SUBSURFACE WASTEWATER DISPOSAL SYSTEM APPLICATION

AUGUSTA

MICHAUD

SUBJECT: New System Variance Approval, Michaud property, Route 104, Augusta

SUBSURFACE WASTEWATER DISPOSAL PLAN

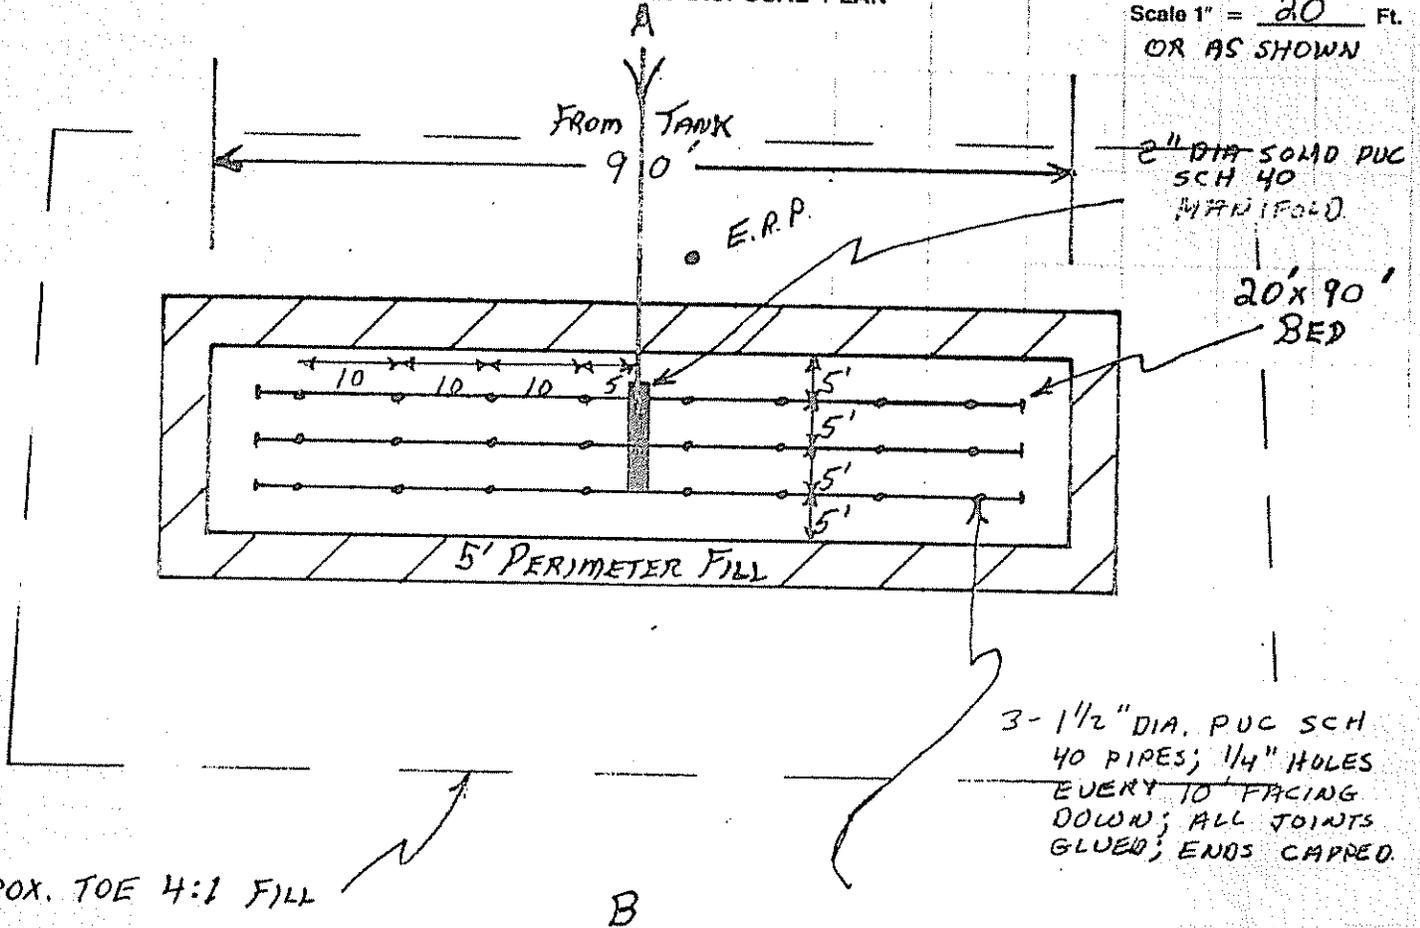
I have reviewed this site with David Roques. He feels that this proposal is acceptable. So do I.

To allow a disposal system to be installed on soils that do not meet the minimum criteria. Specifically, the seasonal high groundwater table is located 6 inches below grade.

The Division approves of the application dated October 27, 1986 by William W. Rideout, SE.

Mr. Rideout shall be retained to establish the system location and elevation at the time of construction.

George A. Soucy, Jr., the Local Plumbing Inspector shall issue a permit prior to the system's installation. The system shall be constructed in compliance with the submitted application.

DISPOSAL AREA CROSS SECTION

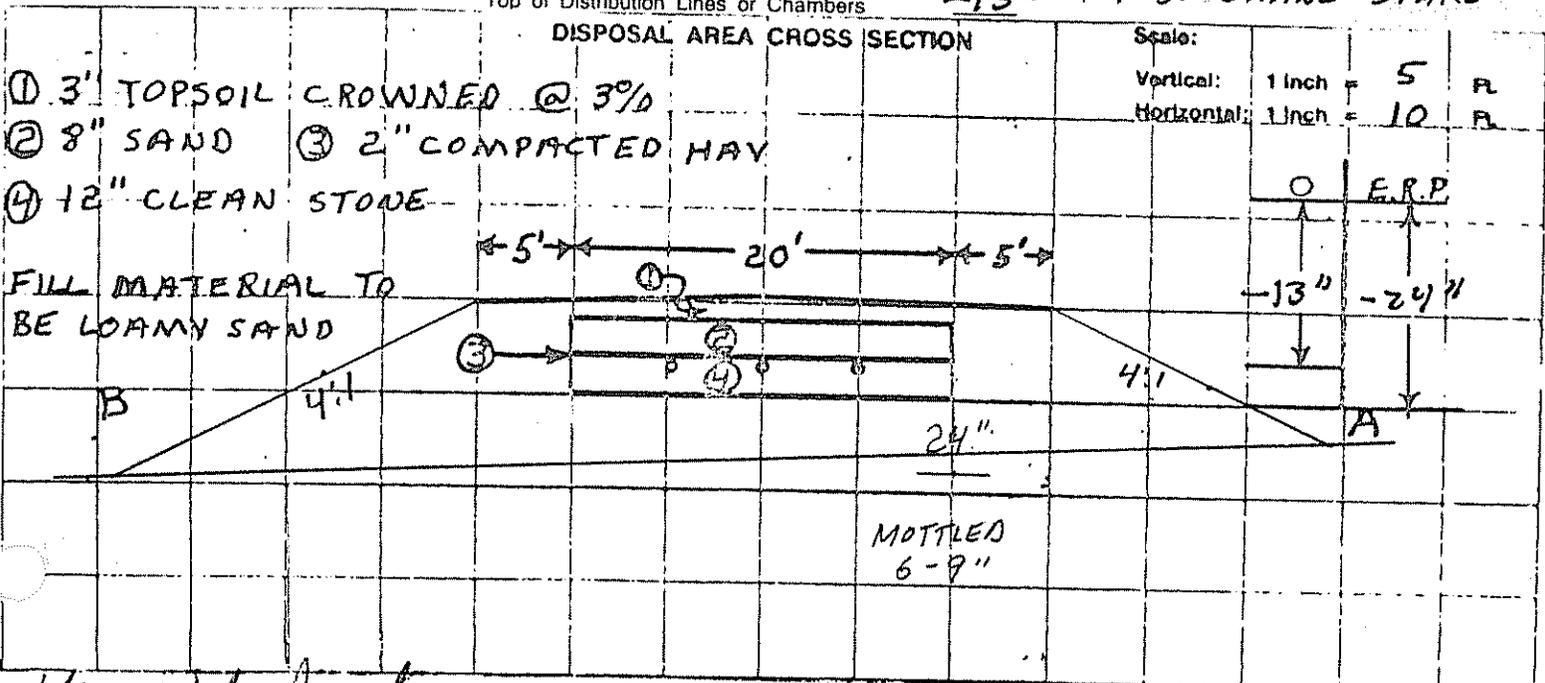
1. BED ON 9-0 SOIL T-6-1
2. _____
3. _____
